STEVE WATSON
& PARTNERS

402 Macquarie Street Liverpool

Accessibility Assessment Report Report 2024/0150 R1.1

Prepared for The Grand Liverpool Pty Ltd
July 2024

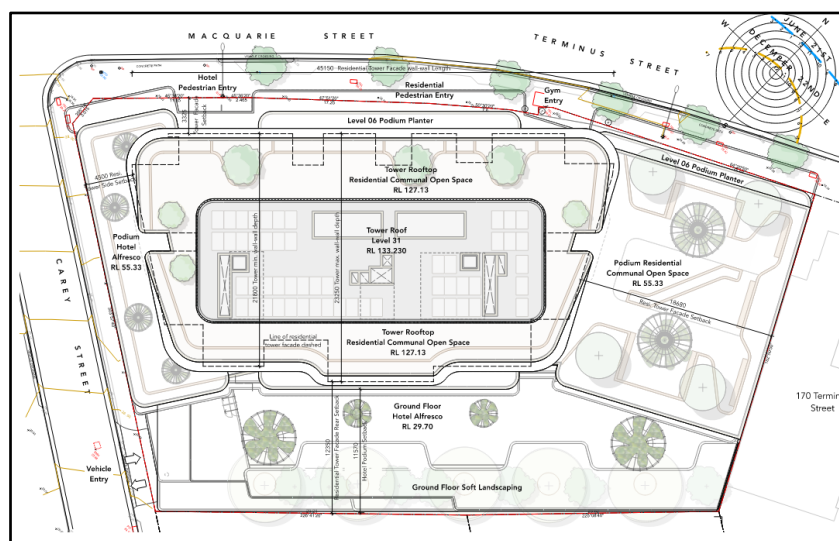
2.	D4D4	Parts of the building to be accessible & AS1428.1-2009	<p>Public corridors in the hotel would not be considered a clear line of sight.</p> <p>Where a clear line of sight is not provided within 20m a passing space shall be provided.</p> <p>Accessways must have a passing space complying with AS 1428.1 at maximum 20 m intervals on those parts of an accessway where a direct line of sight is not available. The passing space shall be a minimum width of 1800mm for a length of 2000mm.</p> <p>Please update the architectural drawings to demonstrate compliance.</p>

Item	DTS Clause	Description	Requirement to Satisfy BCA
			 <p>Figure 3 — Examples for passing space for wheelchairs</p> <p>Passing space for wheelchairs</p>
3.	D4D6	Accessible carparking	<p>The gym has been provided with a single car space, technically this space is required to be an accessible carparking space.</p> <p>The architectural drawings shall be updated to provide a single accessible carparking space.</p>
4.	F4D5	Accessible sanitary facilities & AS1428.1-2009	<p>The accessible sanitary compartment on Level 1 does not satisfy the spatial requirements for AS1428.1-2009. Please update the architectural drawings to demonstrate compliance.</p> <p>Sanitary facility dimension shall be a minimum of 2300mm x 1900mm as per AS1428.1-20090</p>

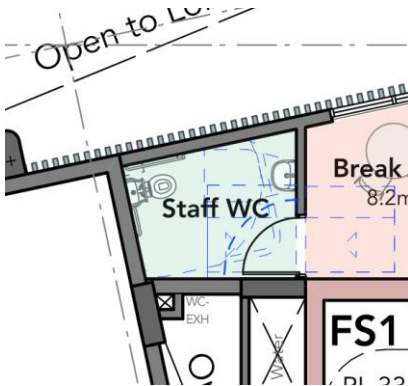
Clause	Description	Comment	Status
		<p><u>Circulation space at doorways</u></p> <p>Compliant circulation space has not been provided at various doorways throughout the development.</p> <p>Circulation space has not been provided at the general manager's office in accordance with AS1428.1-2009. Please update architectural drawings to demonstrate compliance. A minimum 850mm clear opening and latch and hinge side clearances.</p>  <p><u>Turning spaces</u></p> <p>Turning spaces with a clear space of 1540mm x 2070mm has been provided within 2 metres of the corridor ends to allow wheelchair occupants to make a 180-degree turn.</p> <p>Turning spaces have been provided at the end of corridors in accordance with BCA Clause D4D4 & AS1428.1-2009.</p>	Compliance Readily Achievable
		<p>Public corridors in the hotel would not be considered a clear line of sight.</p> <p>Where a clear line of sight is not provided within 20m a passing space shall be provided.</p> <p>Accessways must have a passing space complying with AS 1428.1 at maximum 20 m intervals on those parts of an accessway where a direct line of sight is not available. The passing space shall be a minimum width of 1800mm for a length of 2000mm.</p> <p>Please update the architectural drawings to demonstrate compliance.</p>	Additional Details Required
